KERR WOOD LEIDAL  
consulting engineers

# Rainwater BMP Review

## Appendix A – BMP Review

### A.2 5<sup>th</sup> Street Complete Street Rain Gardens

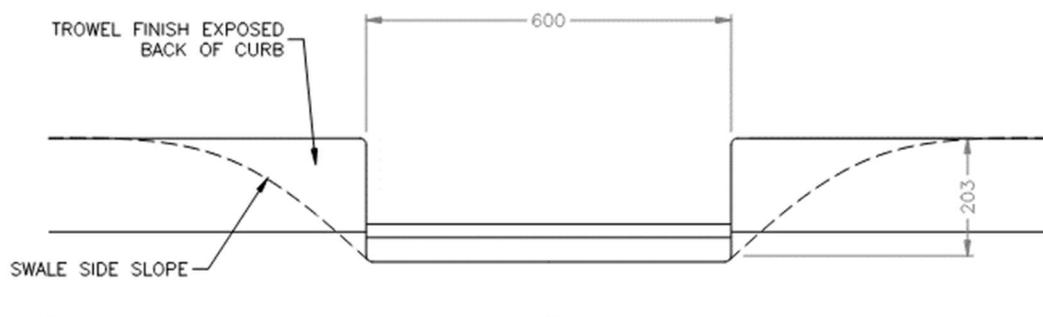
1. The rain gardens received runoff from the street, which enters the rain gardens through curb cuts parallel to the road and traffic direction;
2. The curb cuts lead to a concrete pad and a sediment basin with a grated inlet;

3. The sediment basin is a shallow catch basin, with large (80 mm) drainage holes in the sides, surrounded by peak gravel to allow exfiltration of water into the surrounding rain garden base;

4. Runoff from driveways along this section of street is captured in channel drains that drain to perforated pipes in the rain gardens;
5. Lawn basins in the rain gardens provide an overflow route for any excess water at the surface of the rain garden, connecting to the storm sewer;

6. There are perforated pipes below the rain garden surface that appears to be sloped toward the lawn basins that connect to the storm drainage system. These would provide collection of excess water that cannot be infiltrated below the planted areas;

7. The ratio of impervious area to pervious area (I/P ratio) is approximately 5:1 or less for these rain gardens. This is low enough that there is no concern about pollutant or hydraulic loading overwhelming the treatment capacity of the rain gardens;

8. In-person observation indicates the plantings look healthy, though they do not appear to have spread in all cases, and the rain gardens appear well-maintained. Some sediment removal from concrete inlet pads is needed before the winter season.
